## **8.3 Federal Agency Comments and Responses**

The Draft Environmental Impact Report/Environmental Impact Statement for the Monterey Peninsula Water Supply Project State Clearinghouse No. 2006101004 identifies the potential for the proposed project to impact the Army's existing groundwater remediation system at Fort Ord Operable Unit Carbon Tetrachloride Plume (OUCTP) (Section 4.4.5.2, page 4.4-77). It identifies mitigation measure 4.4-4 (page 4.4-86) which proposes to conduct groundwater monitoring incorporating the Army's groundwater monitoring data, and if an analysis by CalAm concludes that slant well pumping could affect the OUCTP plumes, then "the project applicant will reimburse the U.S. Army for the necessary additional costs to address changes in the plume flow direction, arrest mitigation of the plumes, and/or to remediate areas of new contamination created by slant well pumping." This mitigation measure is later described as requiring CalAm to prevent expansion of the OUCTP plumes.

Thank you for the opportunity to comment on the Draft Environmental Impact Report/Environmental Impact Statement (EIR/EIS) for California American Water's (CalAm's) Monterey Peninsula Wate

Monterey Peninsula Water Supply Project . 205335.01  
**Figure 8.3.2-1**  
 ASR-1 Disinfection Byproducts Parameters

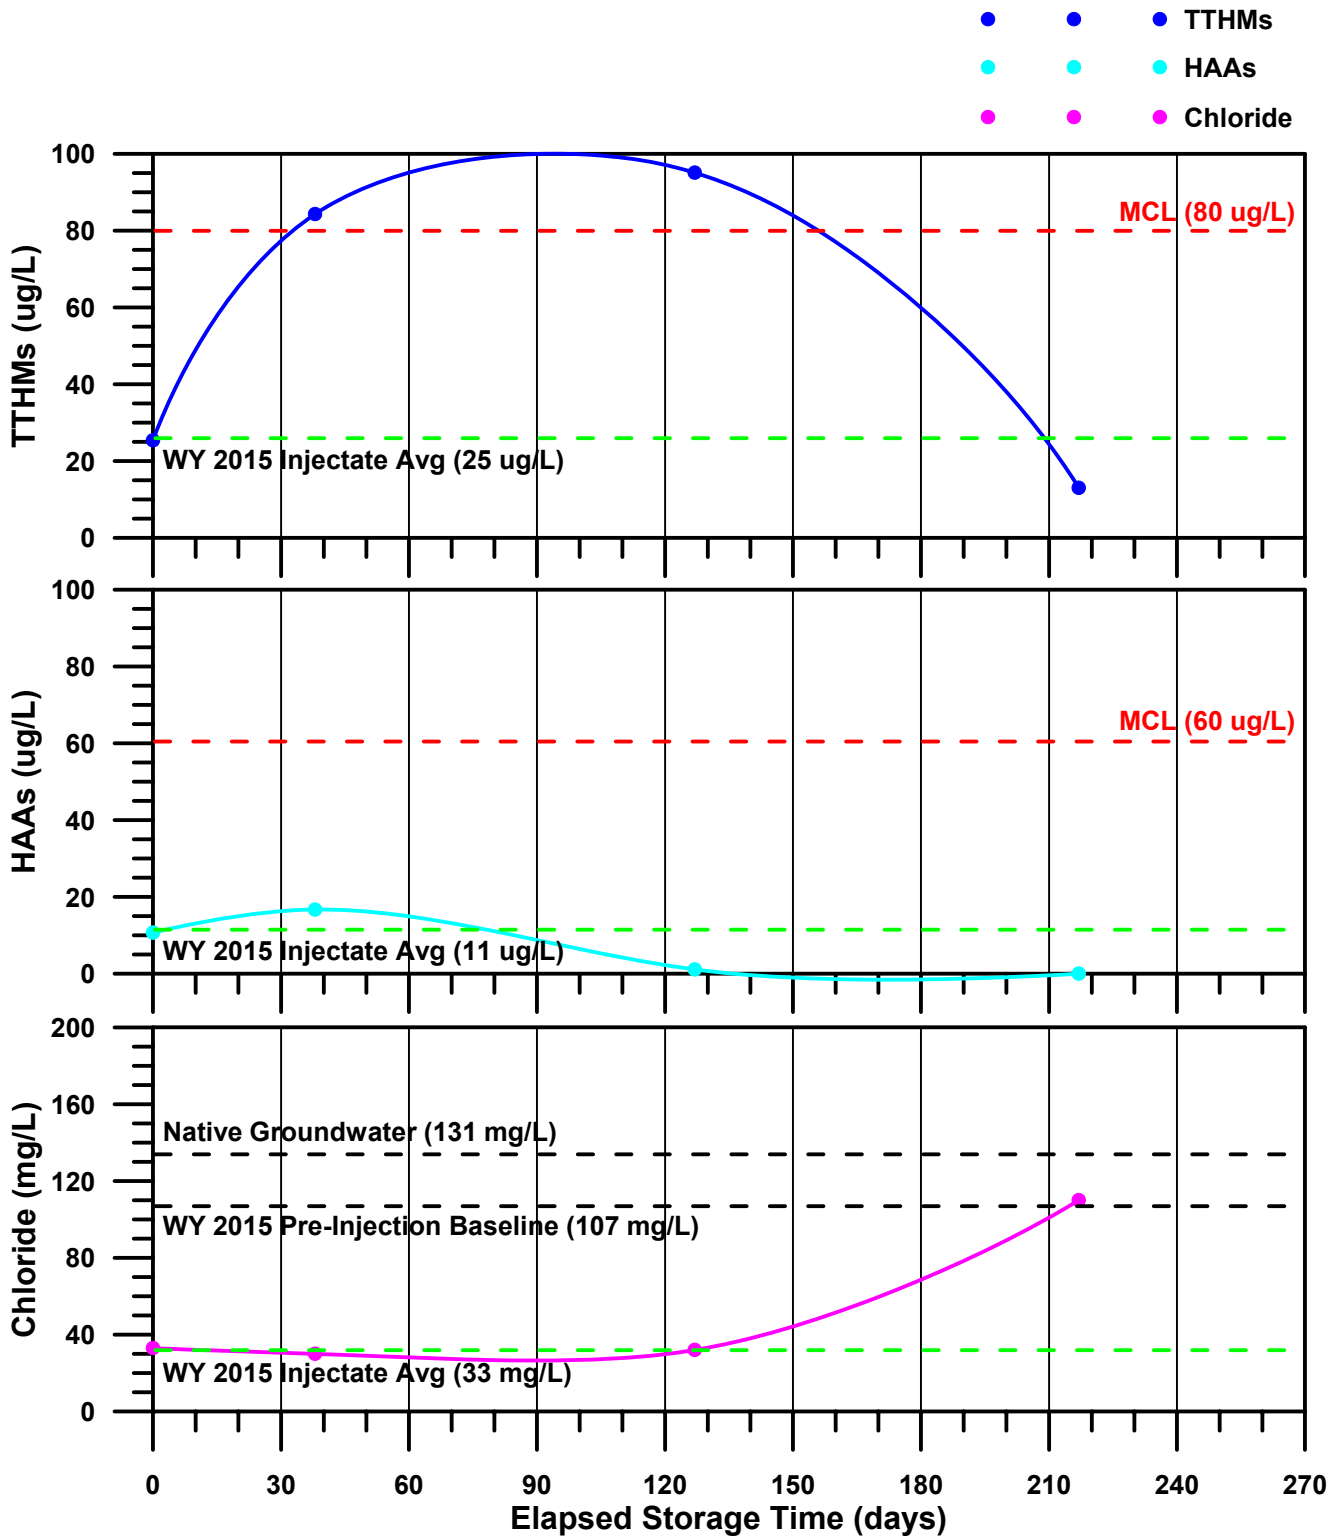
Section 4.4.1.4 states, “The Disinfection Byproducts (DBP) data collected during the 2015 water year indicated that trihalomethanes (THMs) peaked approximately 30 to 90 days after injection and storage, followed by a gradual decline. After approximately 150 to 210 days of storage, THMs had degraded to below the initial injection levels.” However, per the “*Draft Summary of Operations Report for the Monterey Peninsula ASR Project, Water Year 2015*”, dated June 2016, prepared by Pueblo Water Resources for the Monterey Peninsula Water Management District, Figure 22, it appears that THMs exceed the initial injection level after 210 days for the ASR-3 site. Please include a discussion that considers this data.

In order to better understand fate of DBPs and the resulting chemistry of the groundwater, recommend including a table or graph in the Draft EIR/EIS that shows the relative levels of DBPs in the cited 2015 study (and other studies with available data) as compared to the regulatory limits, including pH levels, and including the rate of decline in concentration of DBPs over the given timeframes and the resulting concentrations, to show if the decline in concentration returns to below injection levels or if elevated concentration conditions exist. The proposed amount of yearly injected desalinated water may be higher than the injected 2015 Carmel River water. Please also include details of the study such as the reason for decline in DPB concentration over time and if this pattern of initial increase and decline in DBP concentration is expected to be consistent for larger amounts of injected DBPs.

USARMY-14 The discussion of Disinfection Byproducts in Section 4.4.1.4 has been revised to reflect the cited information about past operation of existing ASR-3:

- USARMY-15 As explained in the subsection titled Disinfection Byproducts in Section 4.4.1.4 Groundwater Quality, the concentrations of THMs in ASR-3 did initially increase and then decrease over time to below the Maximum Contaminant Level (MCL) or 80 micrograms per liter (mg/L). See the revision in response to comment USARMY-14 for clarification that THMs were below the MCL after the initial increase following injection.
